Reference No. 1545831-006

CORONATION NORTH PROJECT CONSENT APPLICATION – GROUNDWATER S92 RESPONSES

**RE : MACRAES CORONATION NORTH PROJECT
EROSION AND SEDIMENT CONTROL
RESPONSE TO s92**

Figure 1: Coronation North Project flow duration results (all stages).

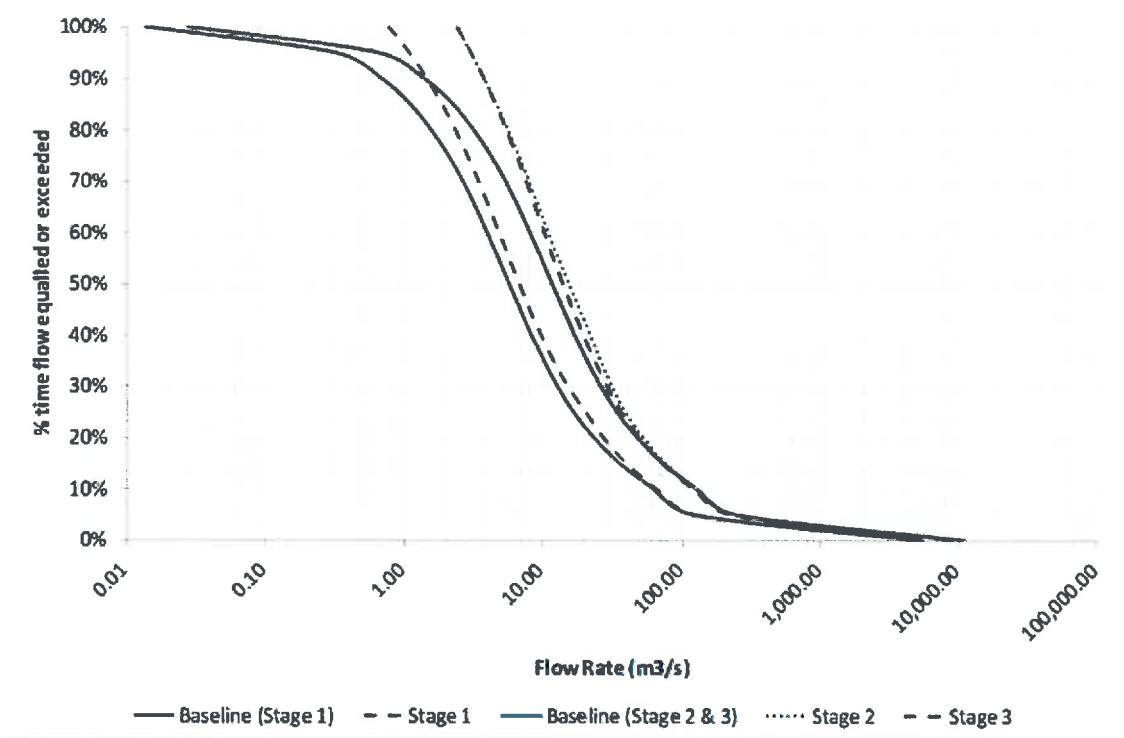
Please provide further information on the cumulative effects of ground drawdown as a result of mining and as a result of the interception of recharge from the waste rock stacks on surface water recharge and its consequent effects on stream flows, including those gullies draining to the Shag River Catchment.

The cumulative effects of groundwater drawdown and changes to surface water catchments on flows in Mare Burn, which discharges to the Taieri River, are documented in Section 6.2.2 of the report documenting the surface water assessment for the Coronation North Project⁷. Three stages of operations were modelled and documented in the surface water report:

- Stage 1 – A model of the Mare Burn catchment incorporating currently consented operations including the Coronation Pit and Coronation WRS. In the model it is assumed that the Coronation Pit and WRS are fully developed and both are still in the operational phase.
- Stage 2 – A model of the Mare Burn catchment incorporating the structures and waste storage associated with both the fully developed CS5 and Coronation North Pits. It is assumed that only the Coronation North pit and WRS are operational. The Coronation WRS is not included in this model as new mine planning has excluded it from the Mare Burn catchment. The Coronation pit lake is assumed to be developing.
- Stage 3 – A model of the Mare Burn catchment incorporating the structures and waste storage associated with both the fully developed CS5 and Coronation North Pits at post closure. It is assumed the WRSs are rehabilitated.

The model logic diagrams and supporting information are documented in the surface water report⁷. The outcomes of the modelling are summarised as flow duration curves in Figure 1. A statistical summary of the projected Mare Burn hydrology under different stages of mine development is provided in Table 20 of the surface water report, together with the supporting documentation.

Figure 2: Stage 3 model logic – Coronation North Project closure.

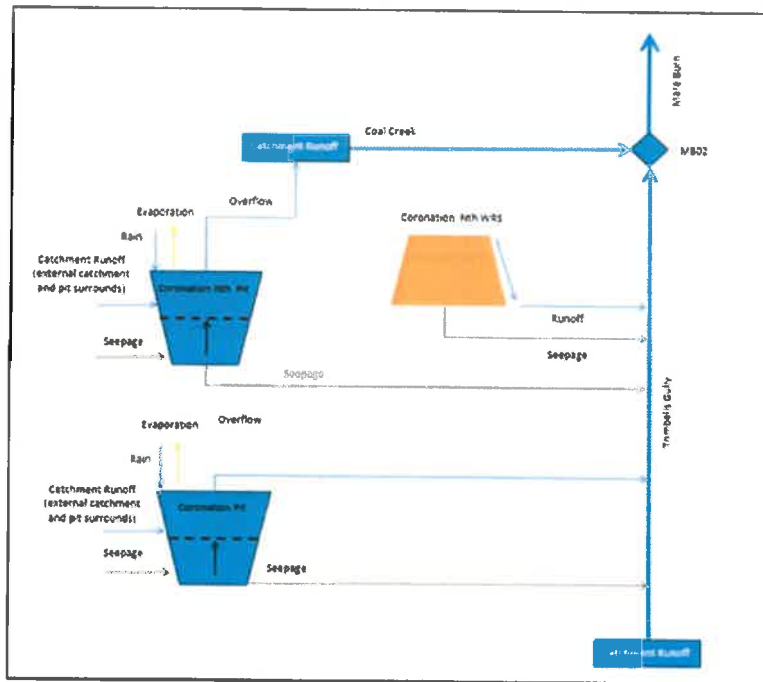
Appendix F provides an assessment of net groundwater inflow into the pit lakes following mine closure and states that these inflow rates have been carried through into the surface water modelling. Please comment on whether evaporation from the pit lakes has been taken into account in the surface water modelling and whether evaporation from the pit lakes has also been taken into account in determining the likely timeframes for filling of the pit lakes.

The modelling of the development of the Coronation Stage 5 pit lake and the Coronation North pit lake does take into account evaporative losses from the pit lake in providing projections for the time required for the pit lakes to reach overflow. This modelling has been documented in the surface water report from Golder⁷ supporting the Coronation North Project consents application. A copy of the Coronation North Project surface water model logic for the stage 3 model (post-closure) is provided in Figure 2. Evaporative losses from the catchment run-off and waste rock stack run-off are also calculated in the model, although not specifically identified in this model logic.

Coronation North WRS
Stage 1

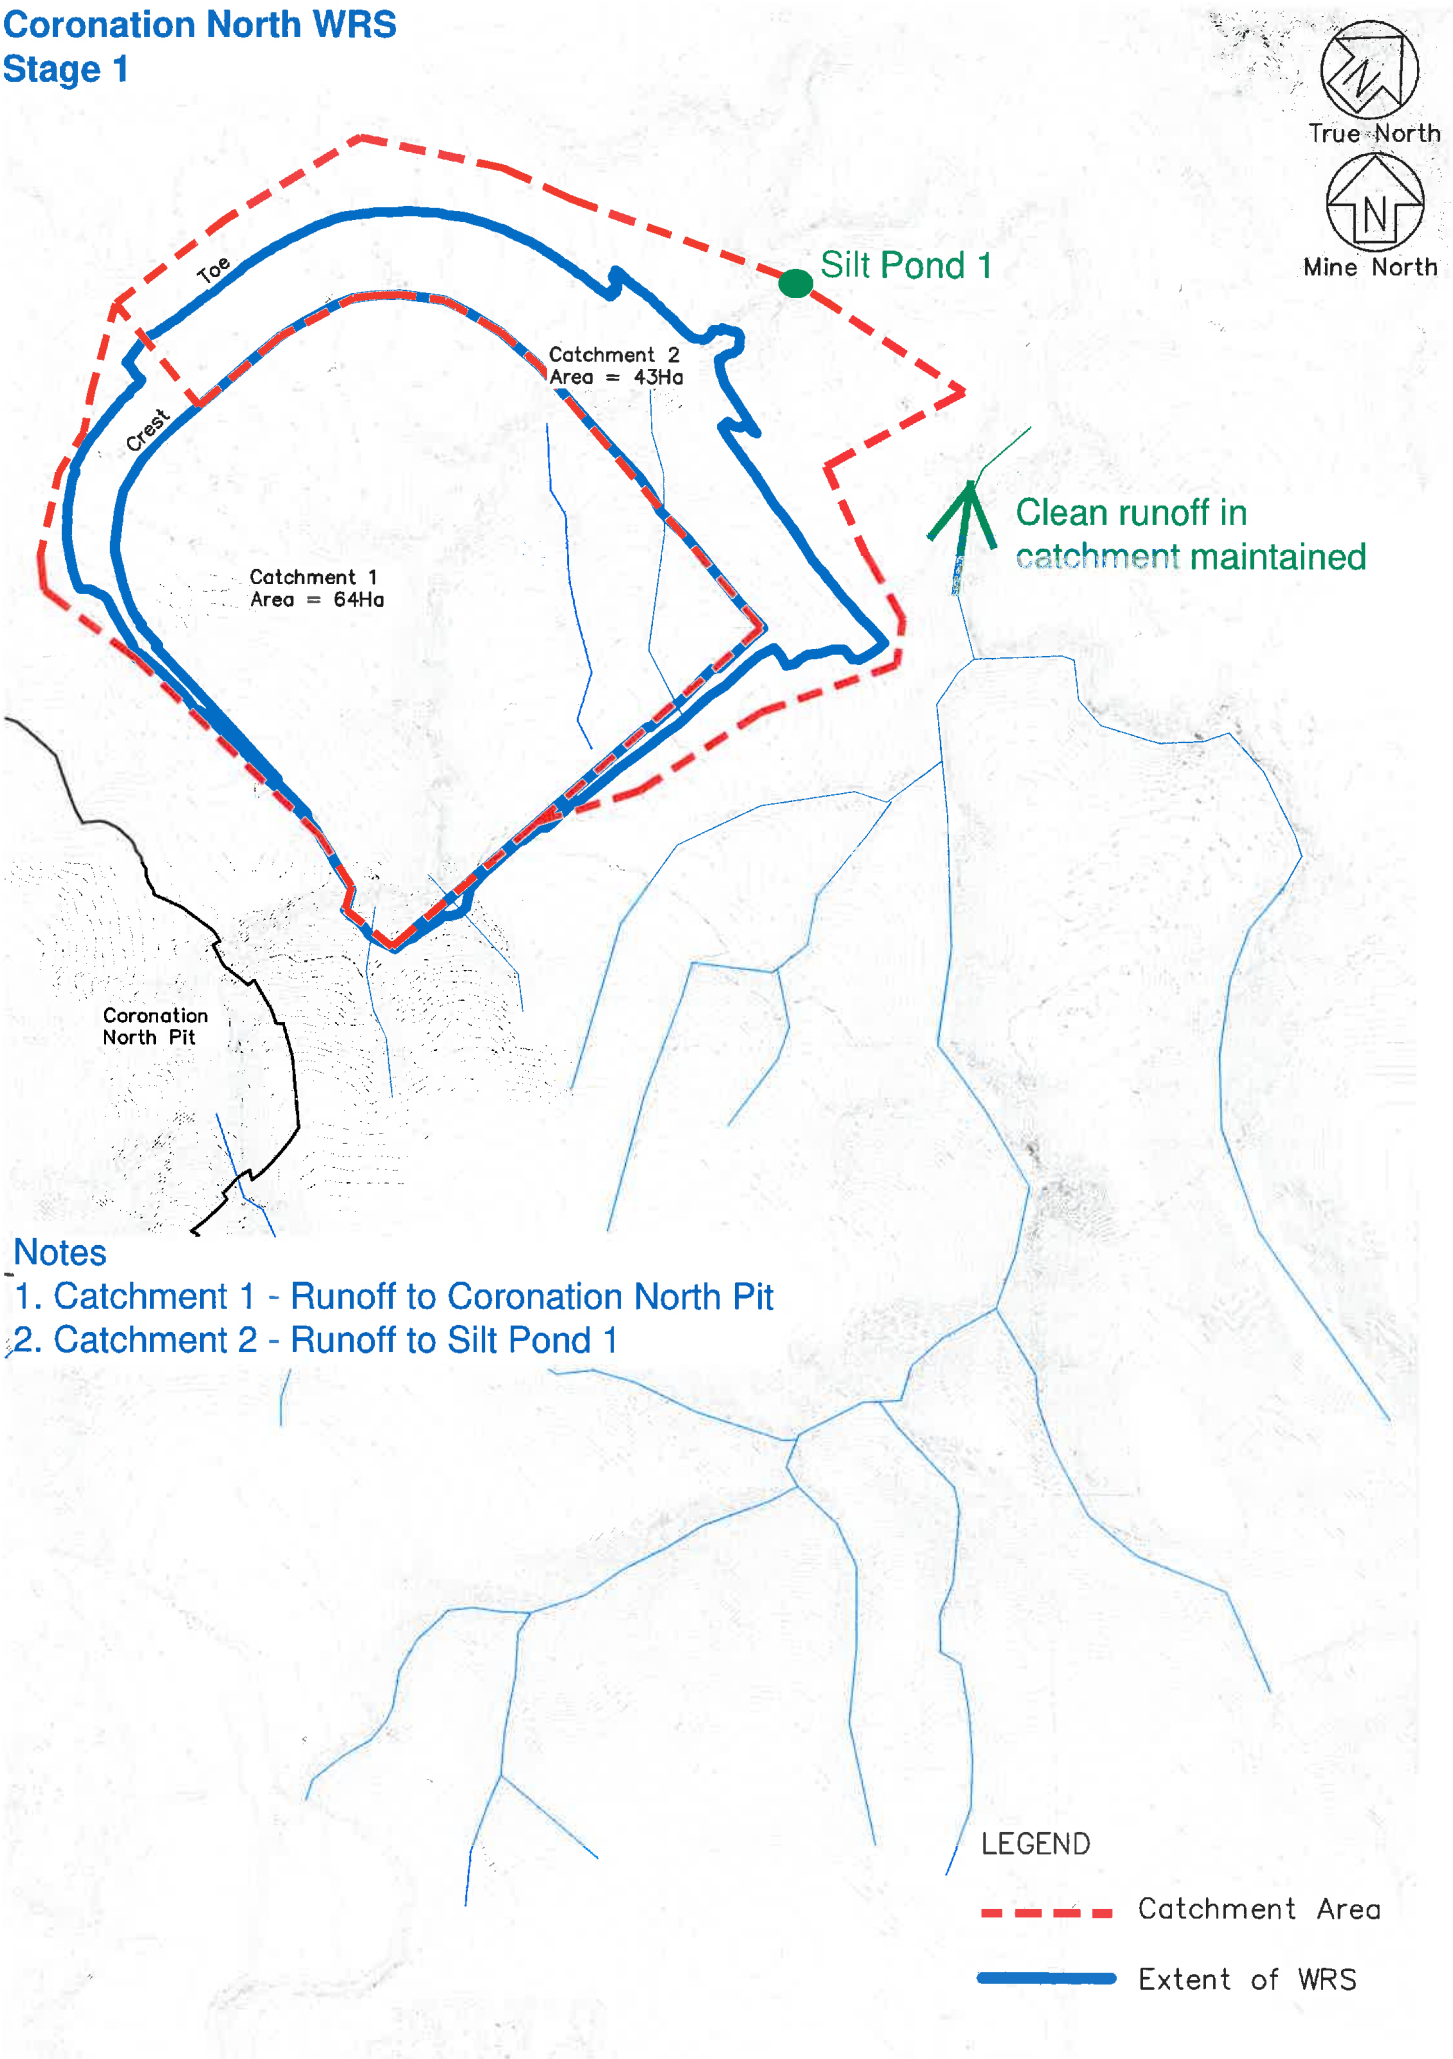
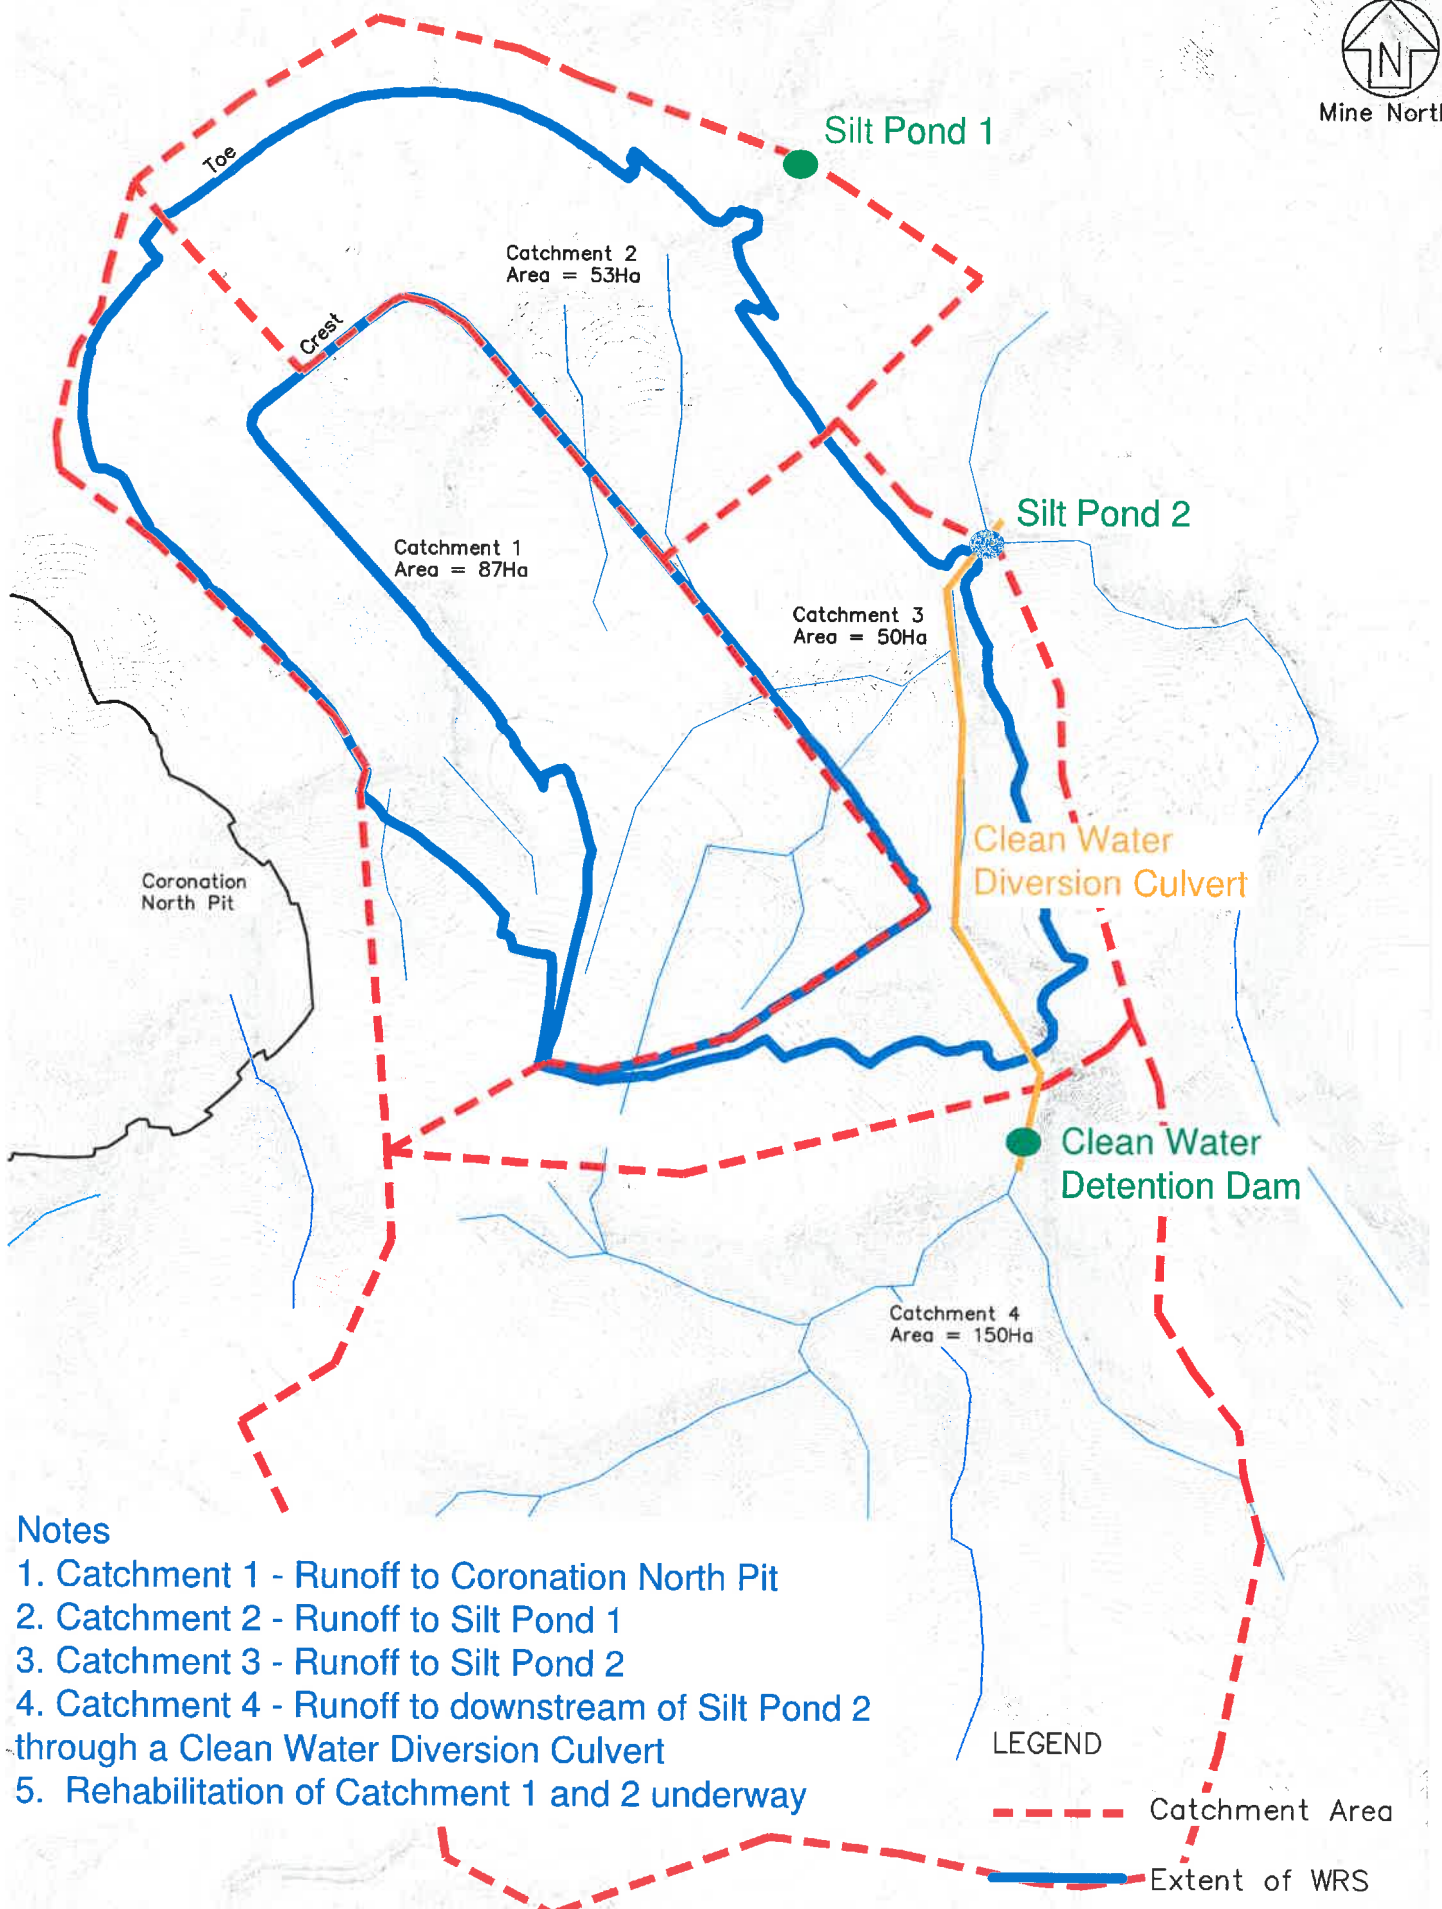
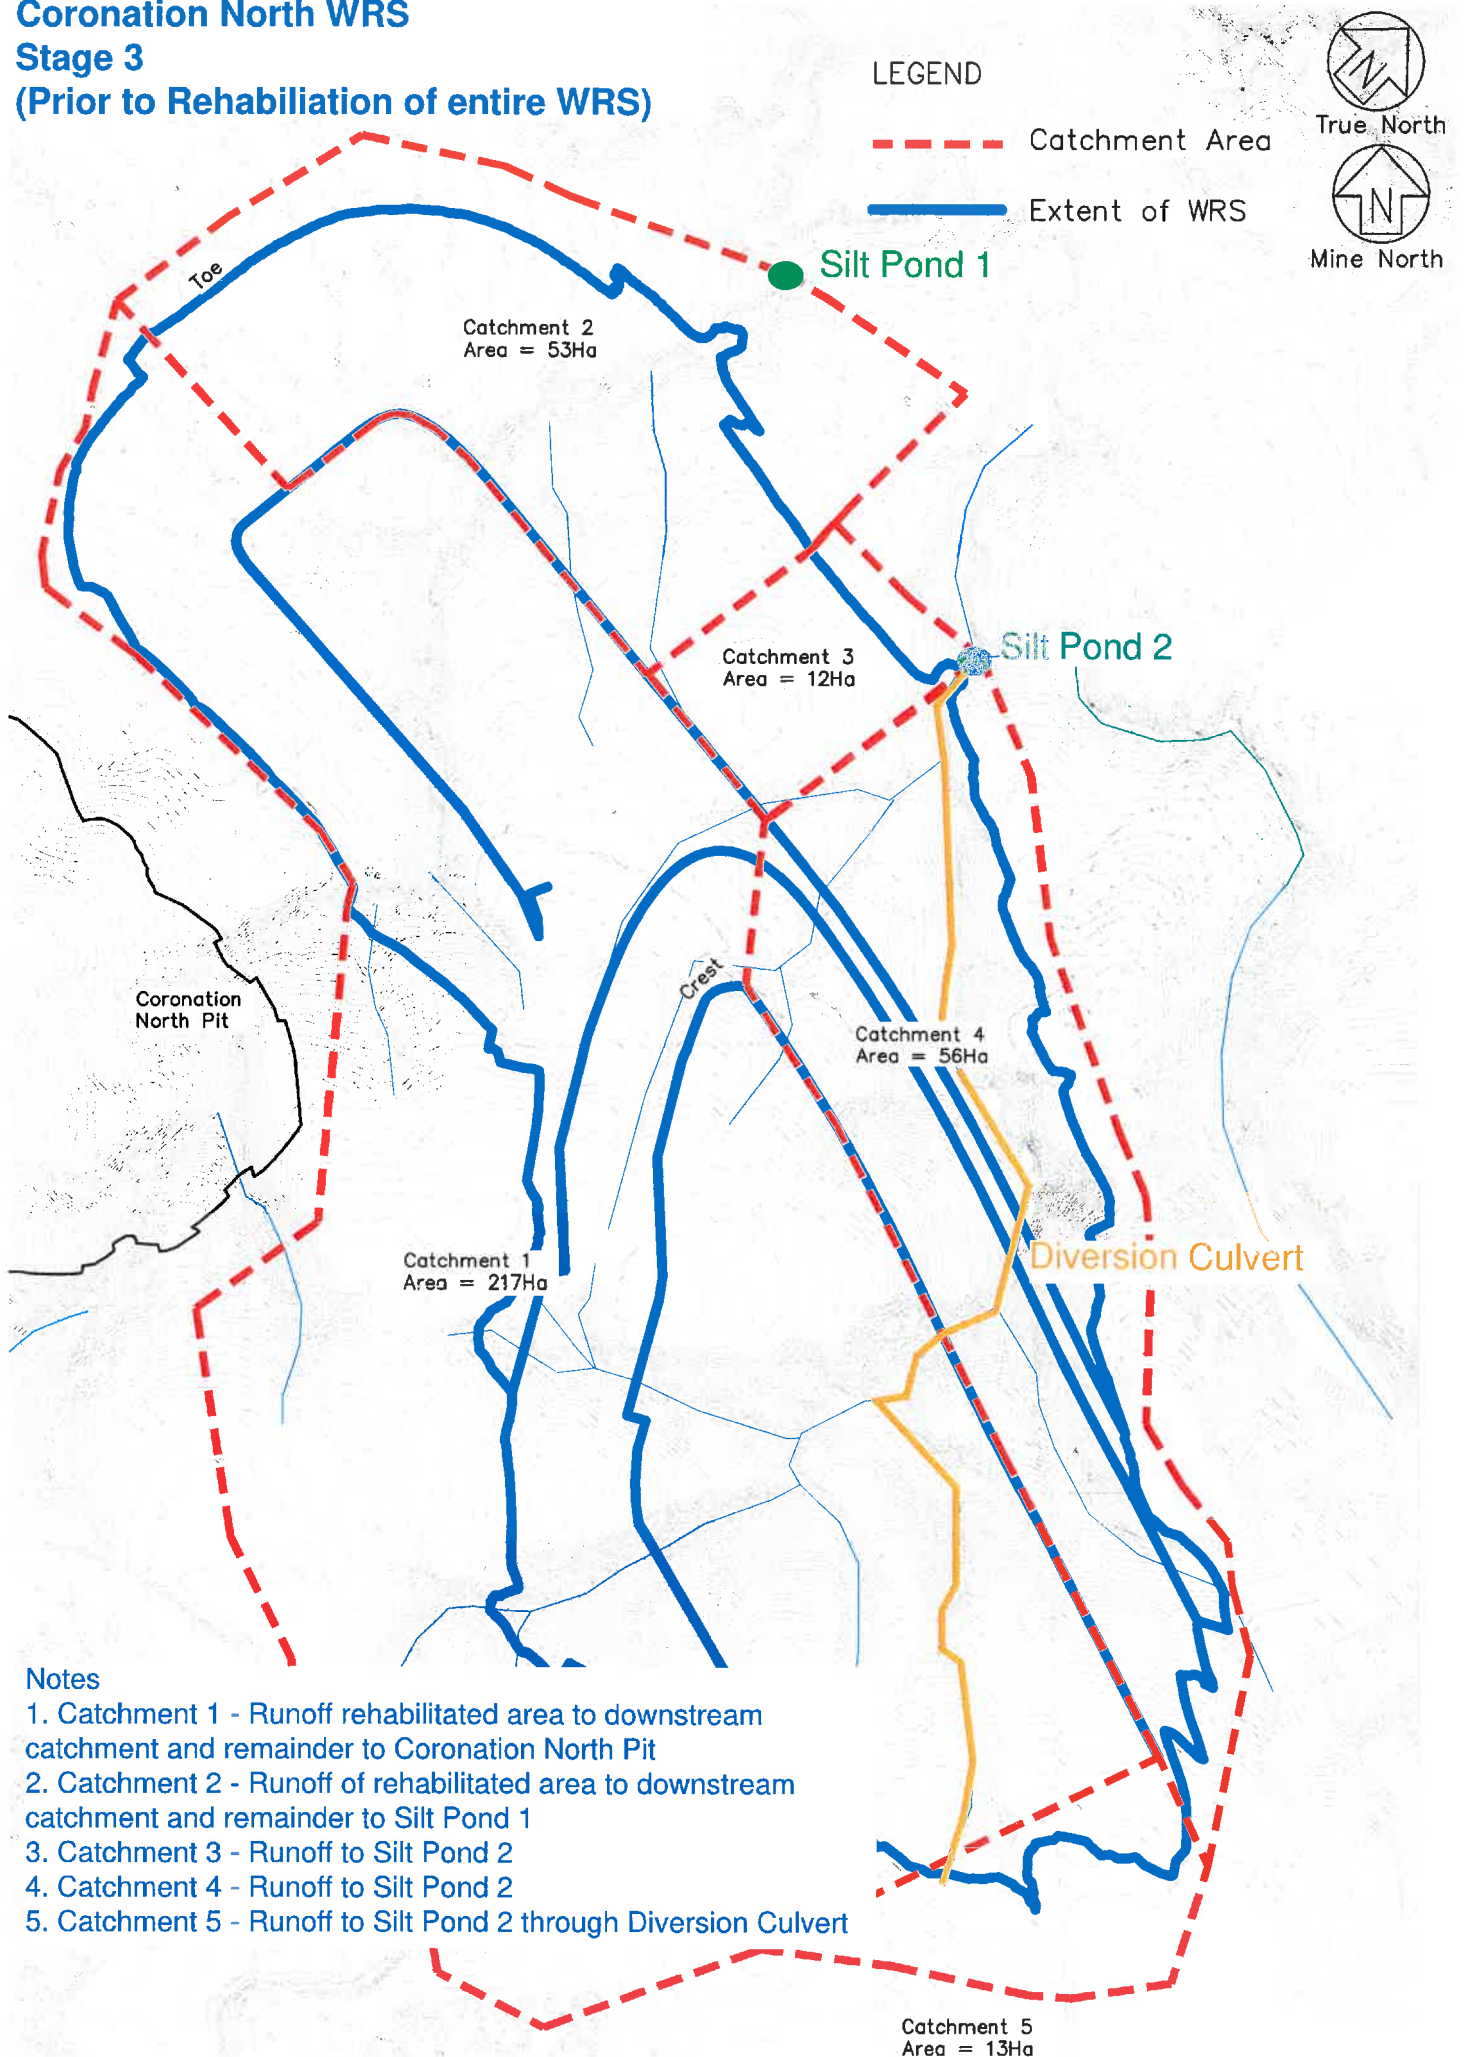
Item h (Catchments)

The attached Stage 1 to 3 plans show how it is proposed to stage the stormwater runoff control for the Coronation North WRS, together with the total catchment areas (refer also

Figure 5 in the ESC report for location of drains). The storage capacity of all the silt ponds is anticipated to be less than 20,000m³ (dead plus live storage). The drain capacities and silt pond dimensions and details will be determined as part of the detailed design for the Erosion and Sediment Control Plan. This will be carried out in consultation with OceanaGold when more detailed information is available on the haul roads and WRS layout and construction sequence.
